INNER WEST COUNCIL

DEVELOPMENT ASSESSMENT REPORT

Application No.	DA201800137.01
Address	15 Simmons Street, Enmore
Proposal	Review request under Section 8.2 of the Environmental Planning and Assessment Act to review Determination No. 201800137 dated 16 August 2018 to demolish part of the premises and carry out ground, first floor and attic alterations and additions to a dwelling house
Date of Lodgement	24 October 2018
Applicant	Seemann Rush Architects
Owner	Mr PM Gonzalez & Mr MG Martignago
Number of Submissions	Application was not required to be notified
Value of works	\$263,000.00
Reason for determination at Planning Panel	Section 82A review of a refused determination
Main Issues	Heritage, streetscape and design, built form and character
Recommendation	Refusal
Attachment A	Assessment Report for DA201800137
Attachment B	Conditions in the circumstance the application is approved
Attachment C	Plans submitted with the review application
Attachment D	Statement addressing reasons for refusal

Image 4: Front Elevation

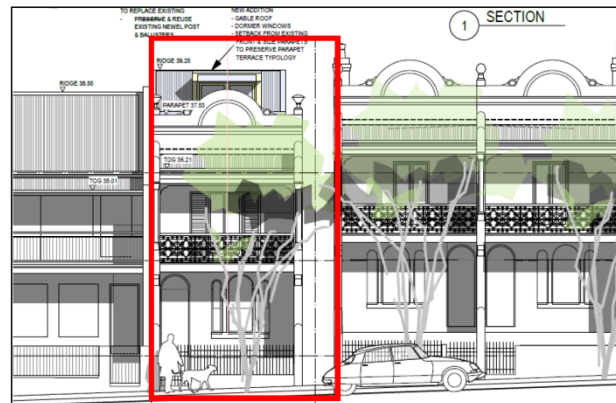
- 8. The proposed third level is contrary to MDCP 2011 Part 8.3 controls C19, 'New development (including extensions to the rear) that will be visible from the street must be no higher than the existing roof form or height of the building and must not overwhelm the existing built form'; C21 'Extensions and alterations visible from the street must be consistent with the overall massing and form of the property (refer to the specific style sheets) and must not dominate the existing building form'; C22 'Existing original roof forms (and, where possible, materials) must be retained to the front elevation and for the length of the main roof to the side elevations'; and C36 'the original scale, proportion, materials and detailing of street facades must be retained. The third level would be visible from the*

street. The third level is higher than the existing roof form. It overwhelms the existing built form. It is inconsistent with the overall massing and form of the traditional parapeted Victorian terrace. It involves demolition of and alterations to the primary original roof form (skillion roof behind a parapet wall). And it would detrimentally impact the original scale and proportion of the street façade.

9. *As stated in MDCP 2011 Part 8.5.1, the Victorian Italianate and Victorian Filigree styles were applied to detached and semi-detached houses (single and two storey) and terraces. The integrity of the roof form is paramount for this building type. Parapeted Victorian terraces were predominantly two storeys with a skillion roof concealed behind the parapet wall. The proposed demolition of the original roof and construction of a third level projecting above the parapet wall, therefore, is contrary to MDCP 2011 Part 8.5.1.2 objectives O1 'To retain and if possible enhance the contribution of the property to the streetscape', O2 'To ensure any change in the HCA is sympathetic to the Victorian Italianate or Victorian Filigree style values of the property and its ability to contribute to the identified heritage values of the area', and O4 'To keep original roof forms and materials and the scale of the building as presenting to the street'.*

10. *The proposed gable roof projecting beyond the parapet wall is poorly considered and does not achieve an appropriate roof form for the typology and period of construction of the parapeted Victorian terrace.*
